SEWAGE DISPOSAL SYSTEM

HOWARD COUNTY HEALTH DEPARTMENT

SUBDIVISION The Woods at Ridgeview LOT Parcel 4 ROAD 15074 Frederick Road

CLARK • FINEFROCK & SACKETT, INC. ENGINEERS • PLANNERS • SURVEYORS		
7135 MINSTREL WAY • COLUMBIA, MD. 21045 • (410) 381-7500 - BALTO. • (301) 621-8100 - WASH.		
DESIGNED <i>Ar</i>	SITE DEVELOPMENT PLAN PARCEL 4 WOODS AT RIDGEVIEW FOURTH(4TH) ELECTION DISTRICT HOWARD COUNTY, MARYLAND	SCALE 1"=50'
DRAWN <i>Ar</i>		DRAWING 1 of 1
CHECKED		JOB NO. 08-042
DATE 11-19-98		FOR: CROSEN HOMES 3775 Shady Lane Glenwood, Maryland 21738

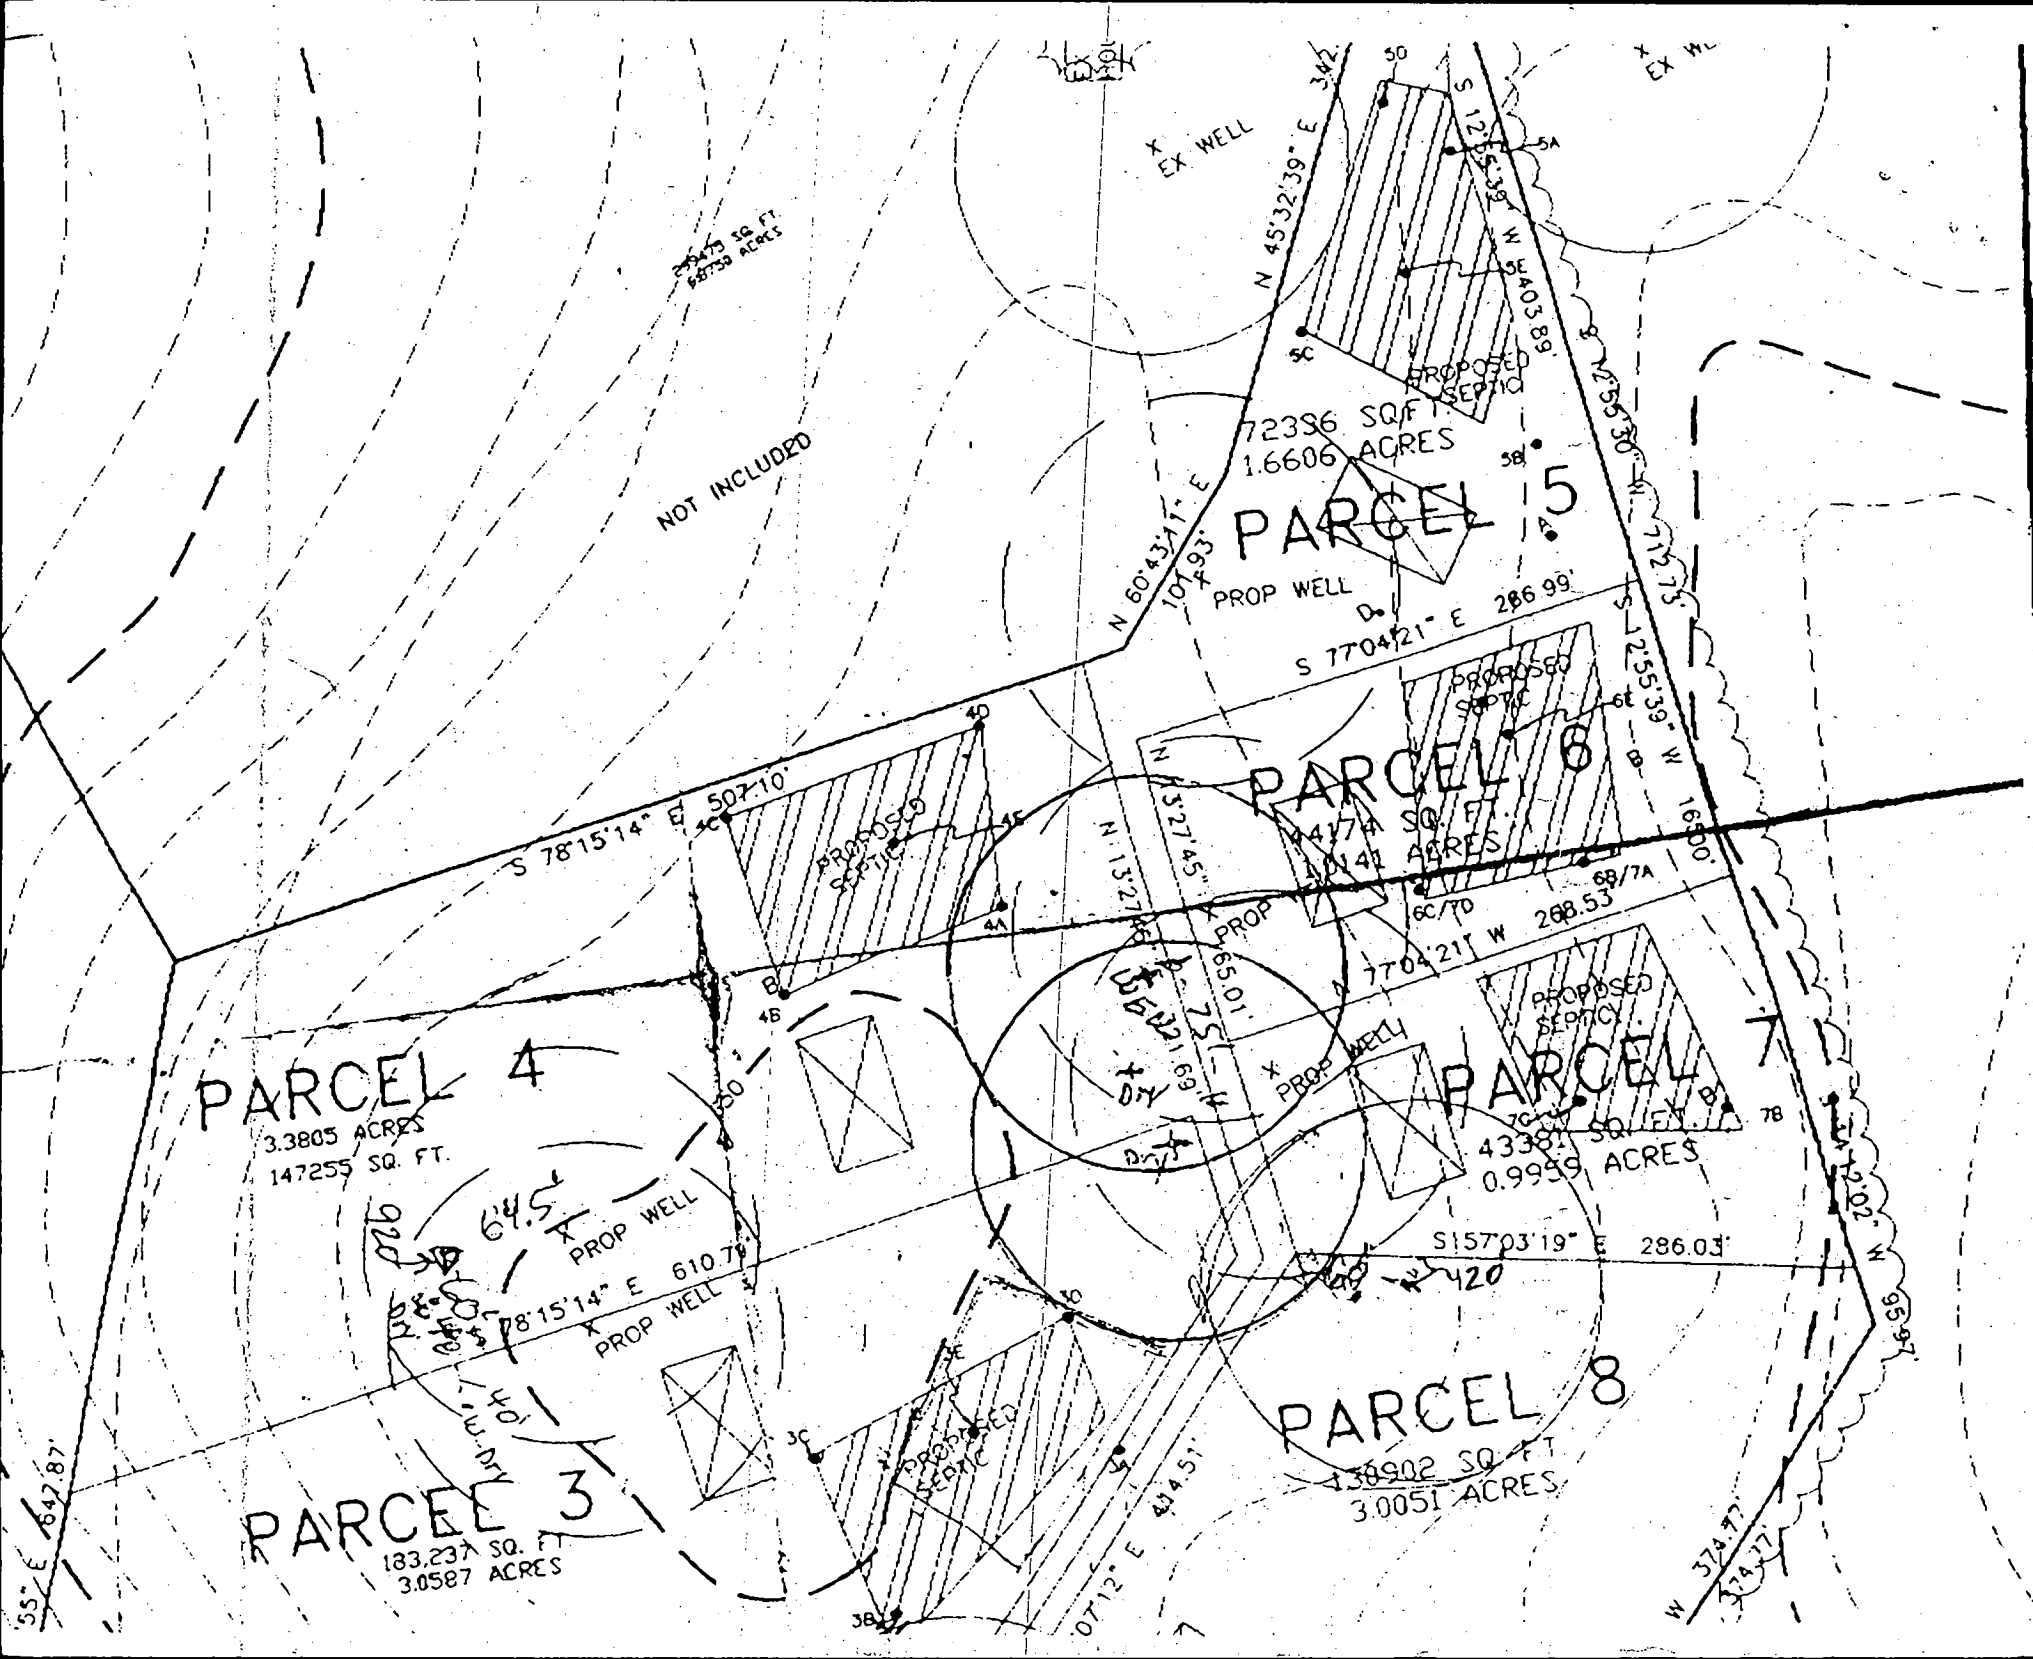
This office has recently received the above referenced building permit application. However, we are unable to approve the application at this time for the following reason(s):

- No water supply has been established to serve the proposed dwelling.
No septic elevations have been provided on the site plan submitted.
Incorrect septic specifications utilized in proposed septic system design.
No invert elevation(s) provided for:
Proposed house to less than feet.
Existing well to less than feet.
Sewage easement location/configuration incorrect.
X Other: building permit is unable to be approved until percolation certification plat has been signed.

SIGNED 12/30/98
- AREA IS APPROACHABLE
EVEN THOUGH
COMPOSITE PLAT FOR
SEVERAL ASSOCIATED PROPERTIES
NOT YET
SUBMITTED
CW

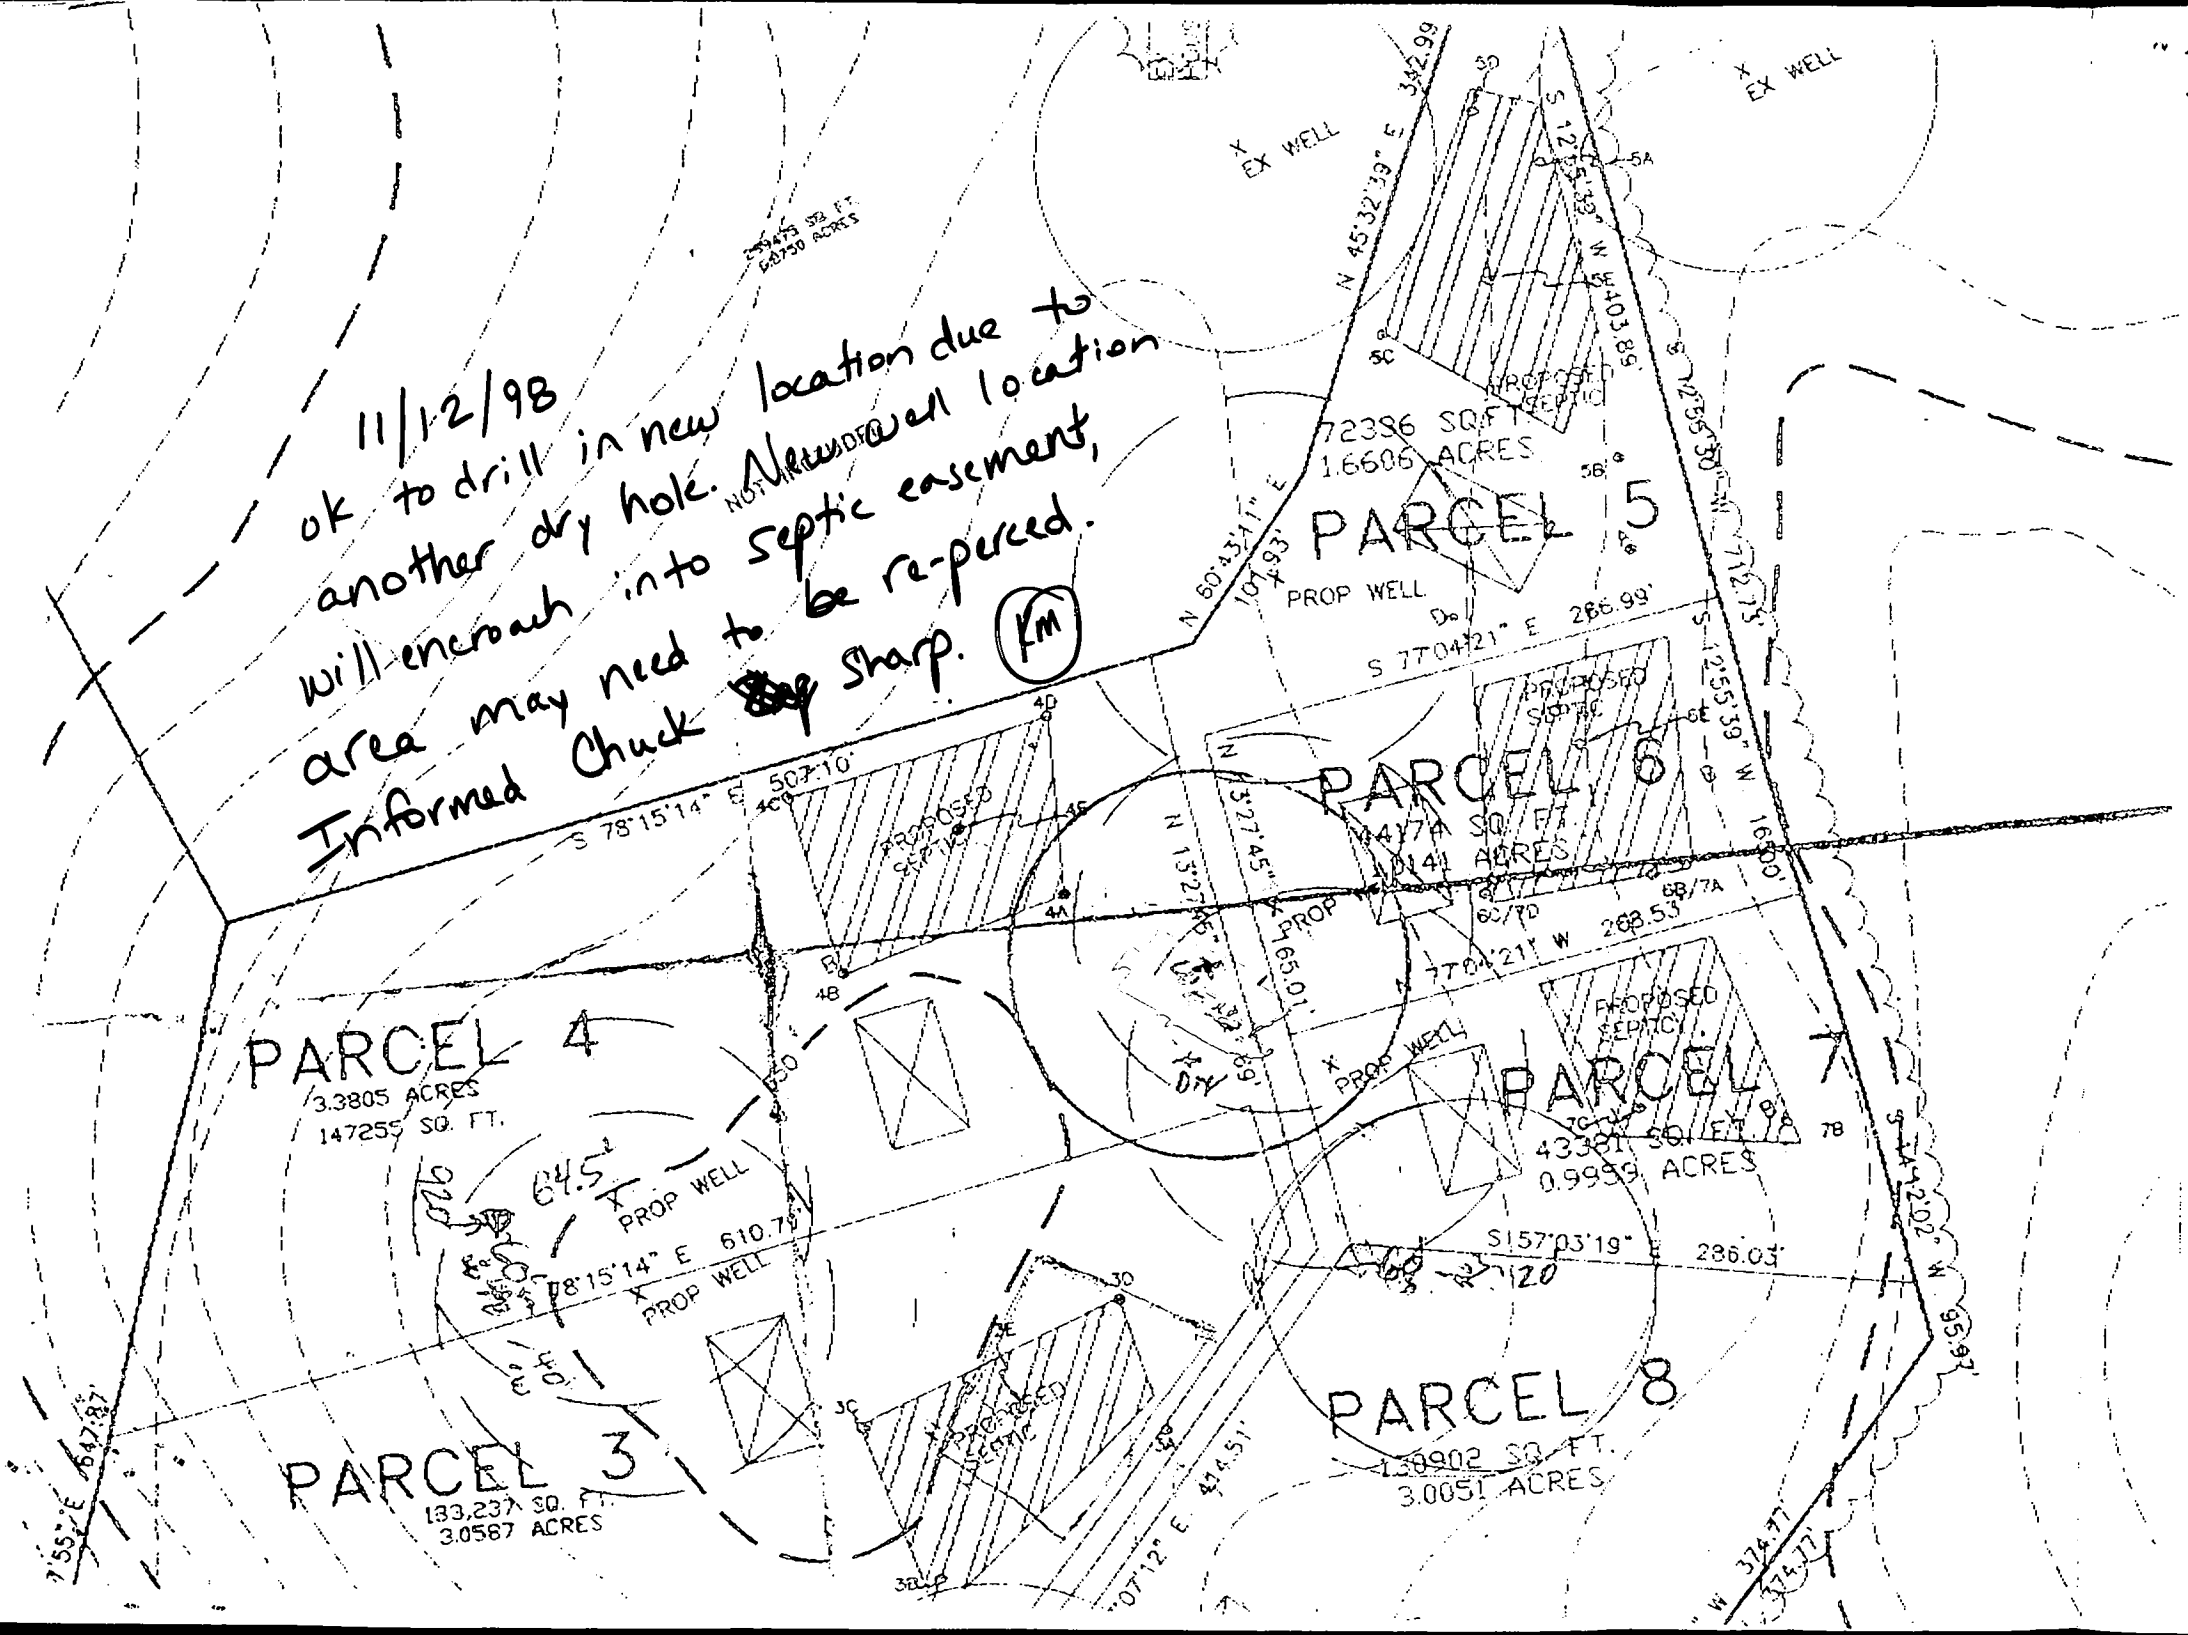
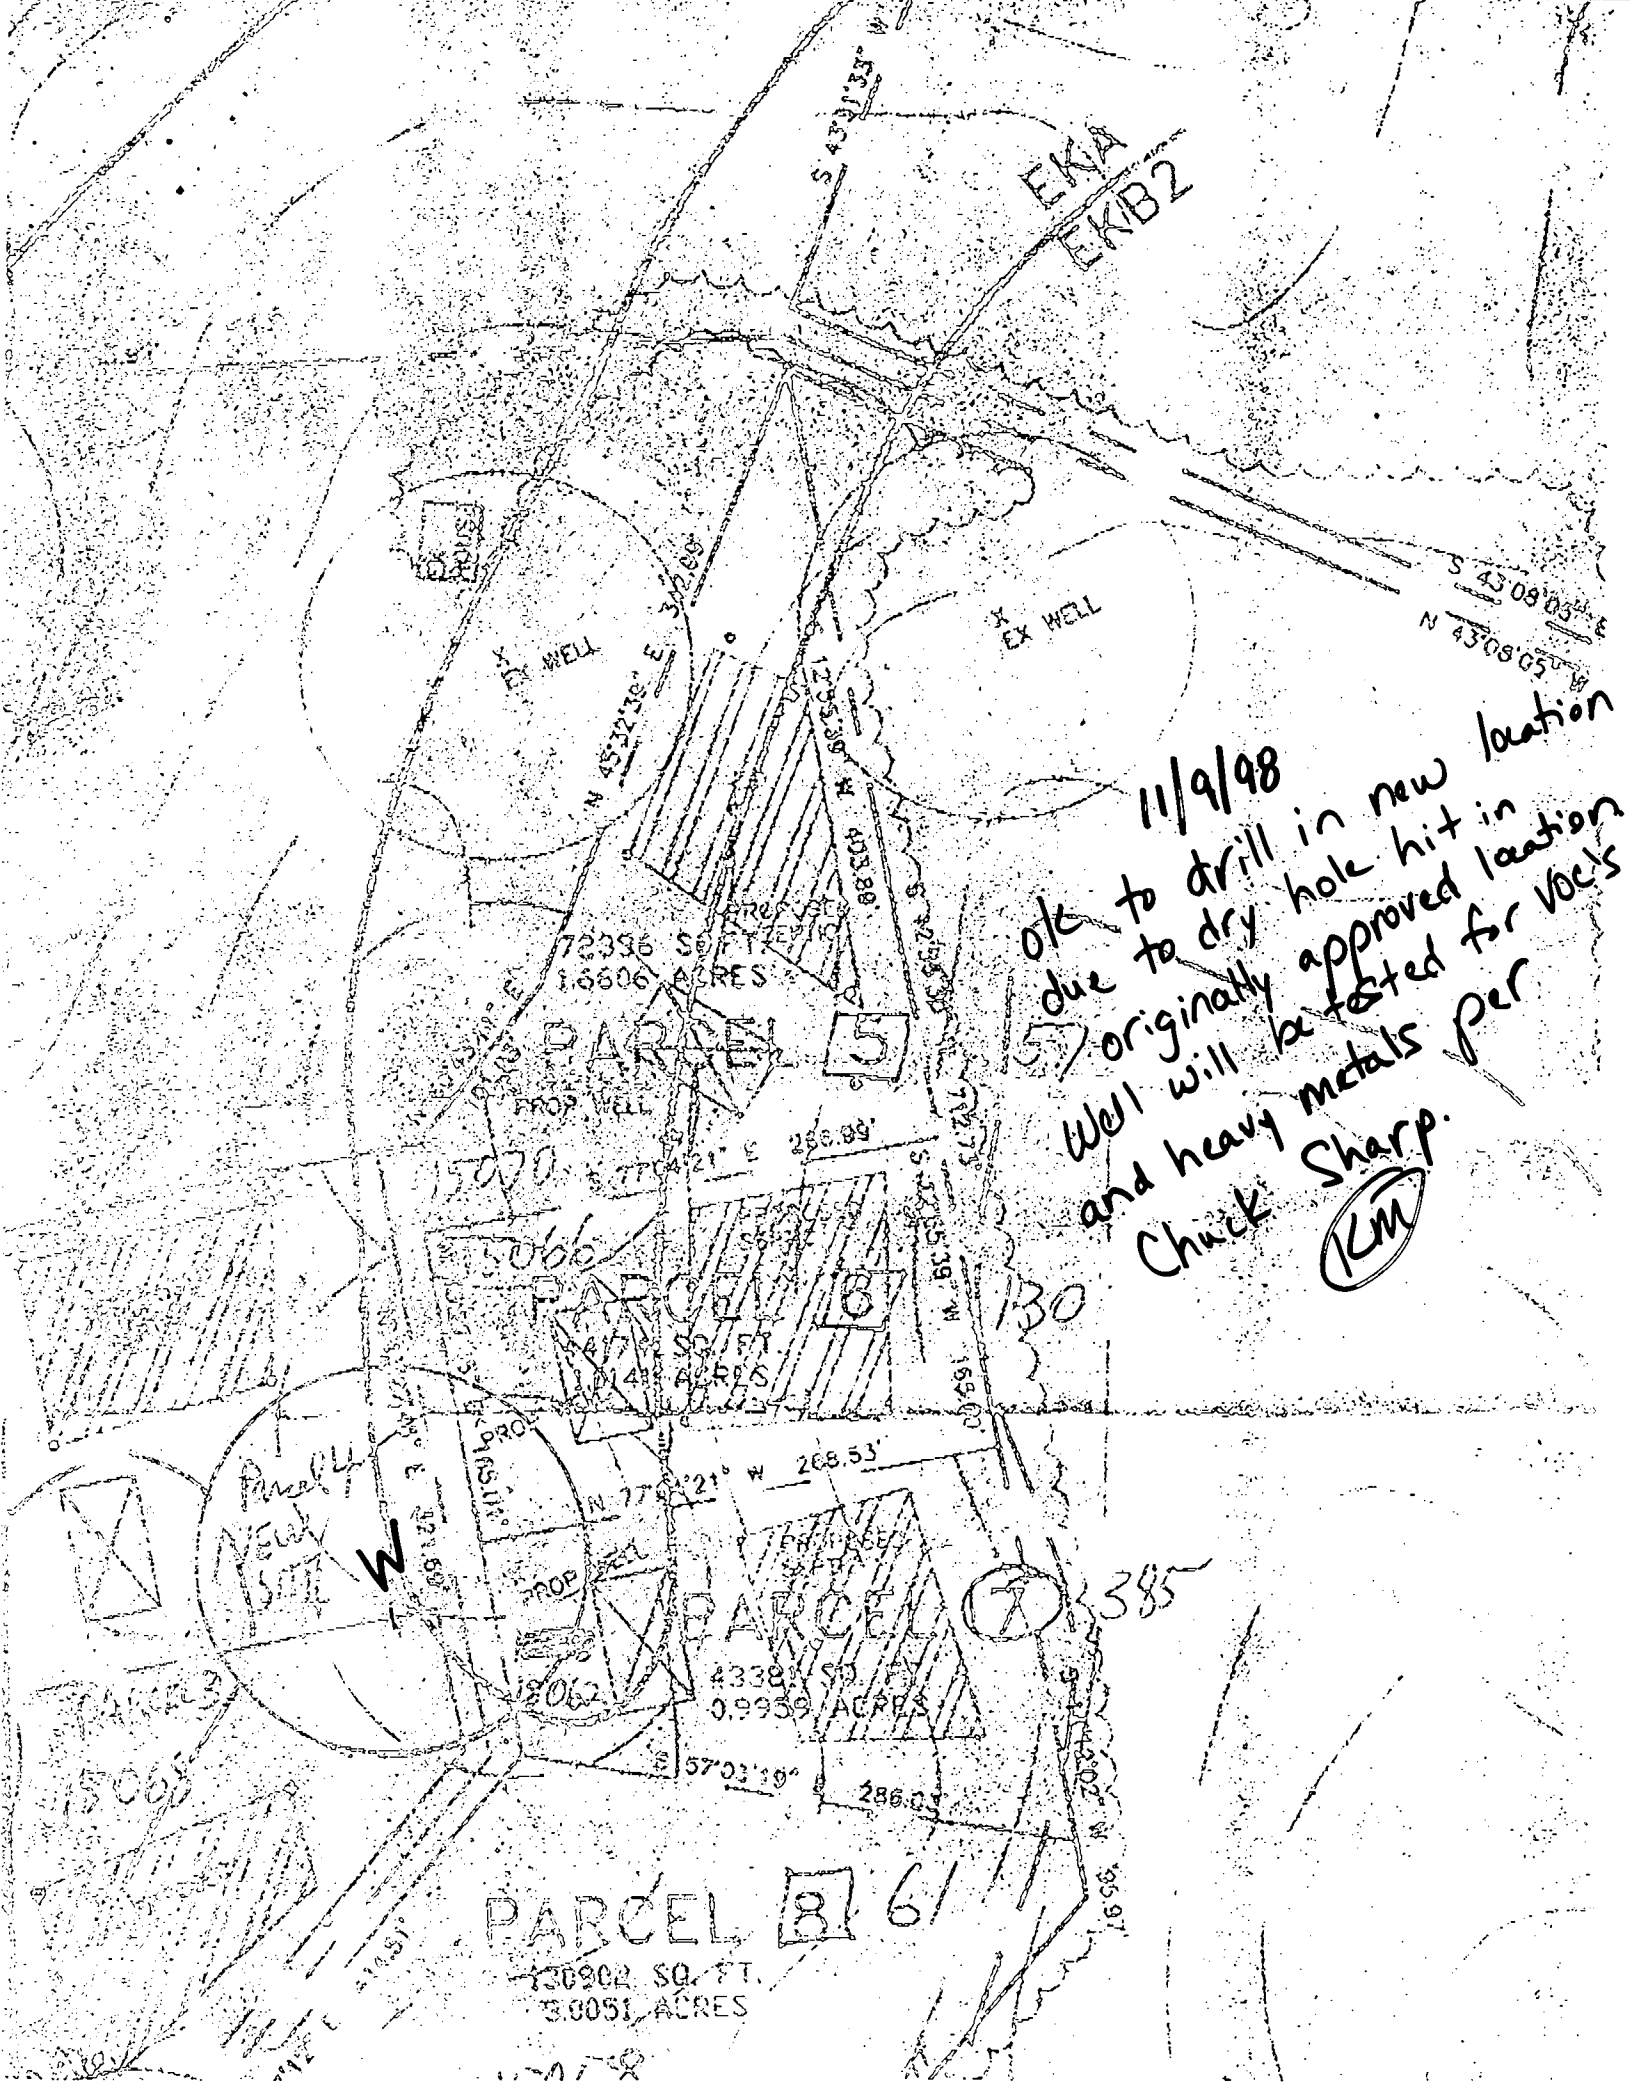
11/12/98
OK to drill in new location due to
another dry hole. ^{NOT A NEW} well location
will encroach into septic easement,
area may need to be re-perced.
Informed Chuck ~~of~~ Sharp. (KM)

11/9/98
 OK to drill in new location
 due to dry hole hit in
 approved location
 and heavy metals per
 Chuck Sharp.
 (KM)

OK to drill in new location due to dry hole hit in ~~original~~ location. Well will be tested 9/17/98 for VOC's and heavy metals per Chuck Sharp. **KM**

OK to drill in shaded area KM/CW
